SUBJECT: Forwards annual const noise progress rept, "Sound Level Measurements Near Susquehanna Steam Electric Station Site Const 1980."

SUSQUEHANNA STEAM ELECTRIC STATION
CONSTRUCTION NOISE PROGRESS REPORT
ER 100450 FILE 991-2
PLA-837

SUBJECT: Study on Torsional effect on the seismic
response analysis of (1) ESSW Pumphouse
(2) Diesel Generator Building

TYPICAL WALL FIXES

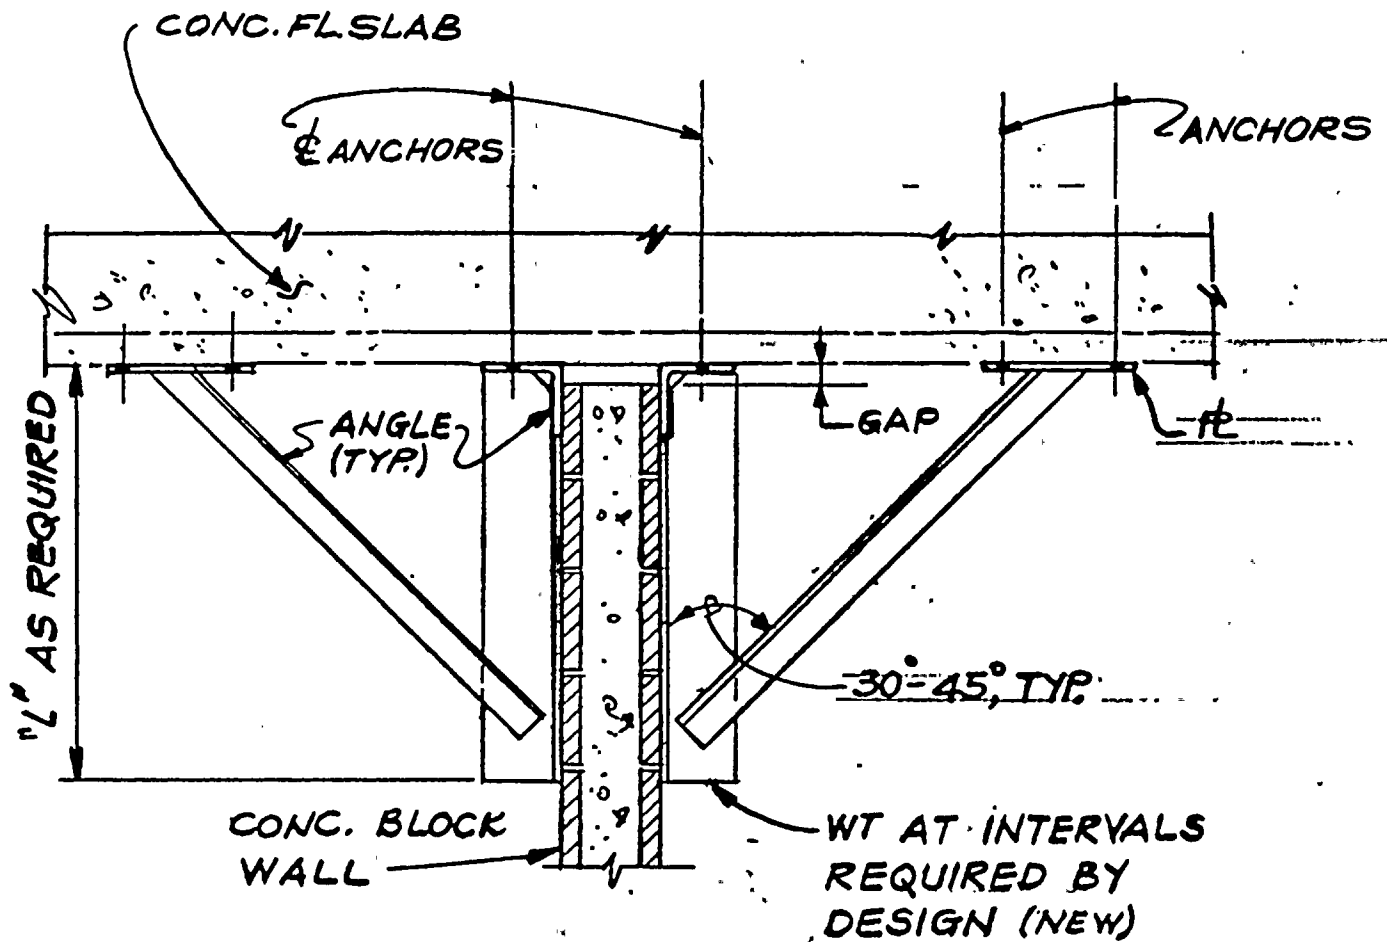
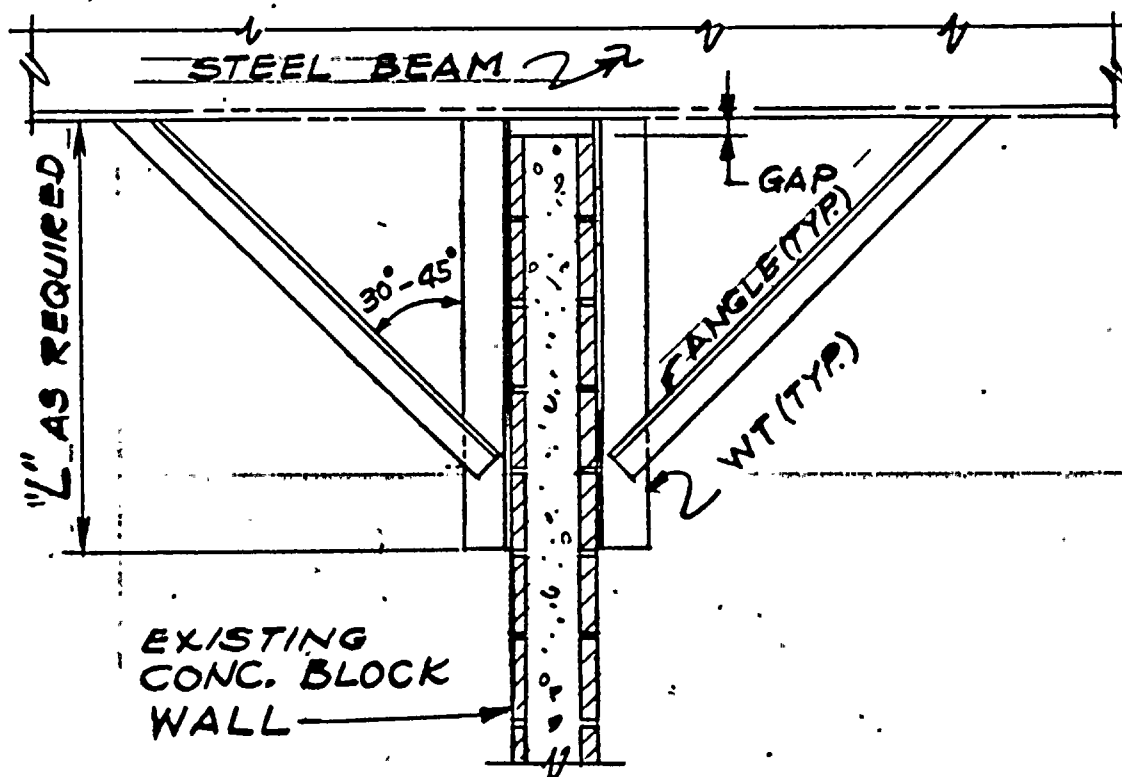
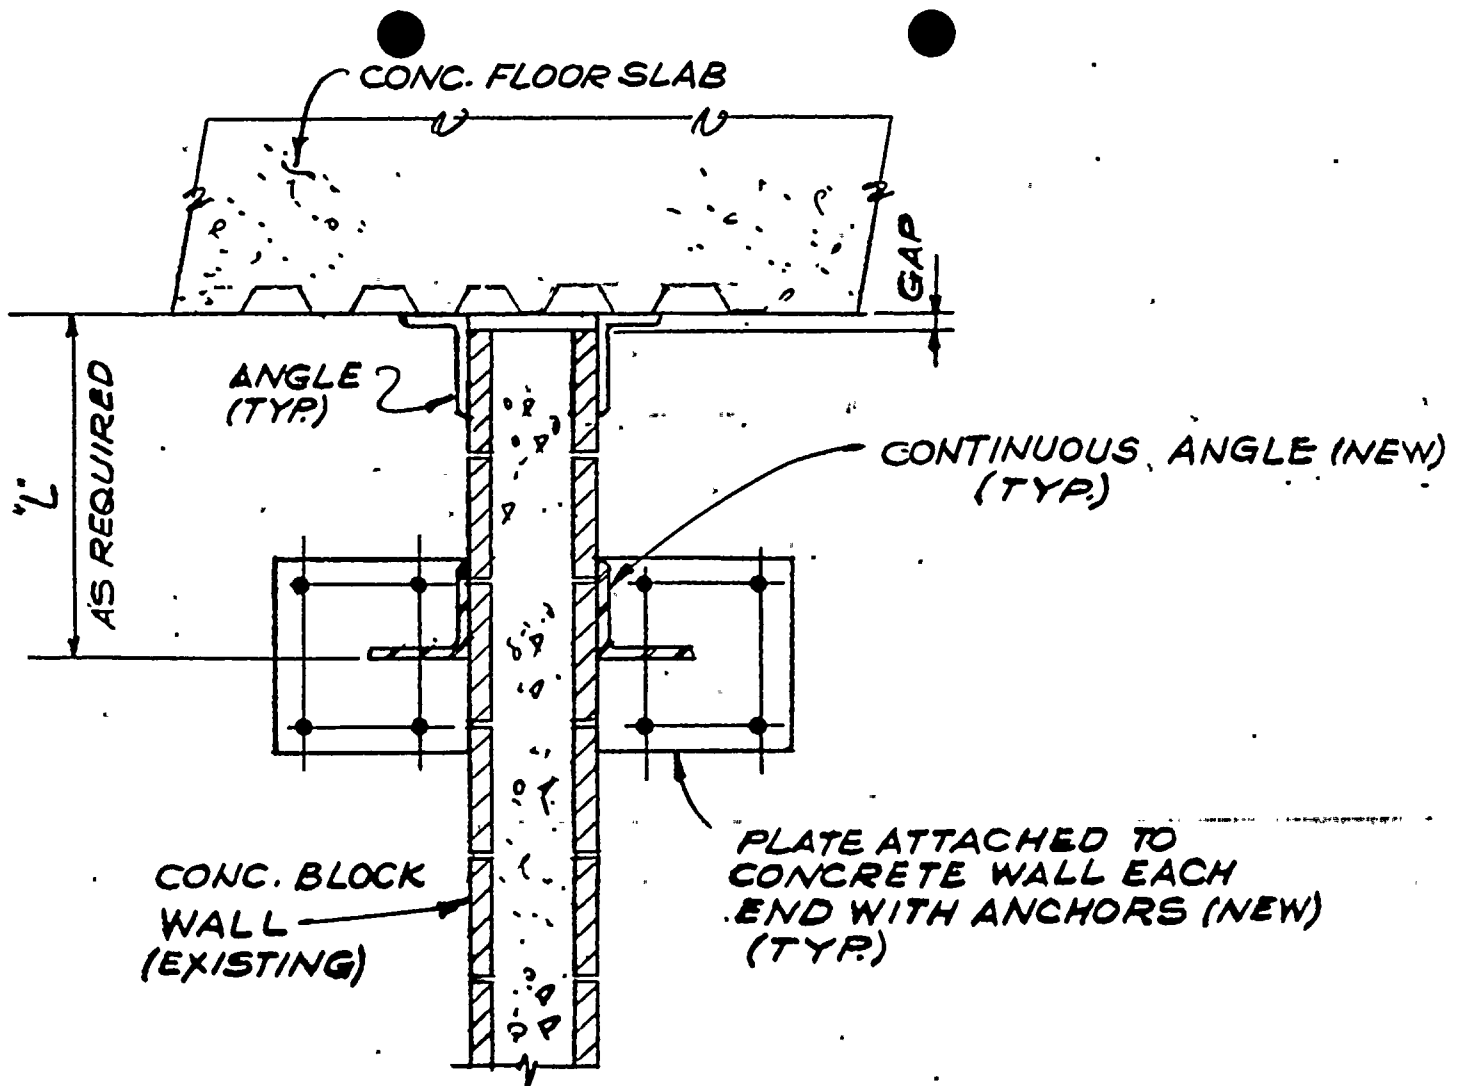
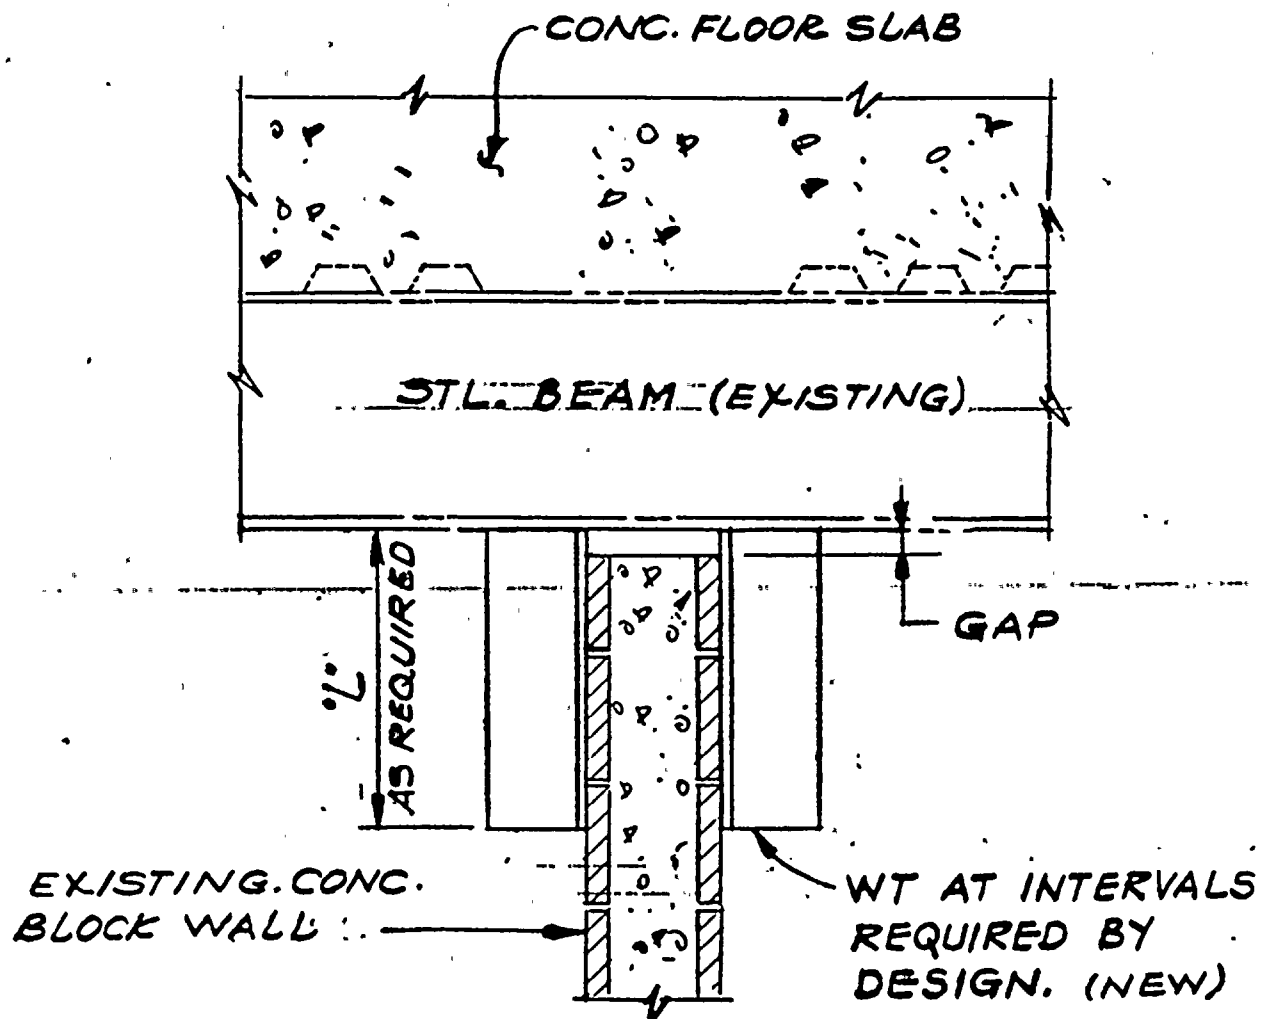
In response to Question 5, it is stated that when the design stresses of masonry walls exceed the allowable stresses, fixes are designed such that the criteria is satisfied. Indicate the number of walls where such fixes are needed and provide examples.

RESPONSE:
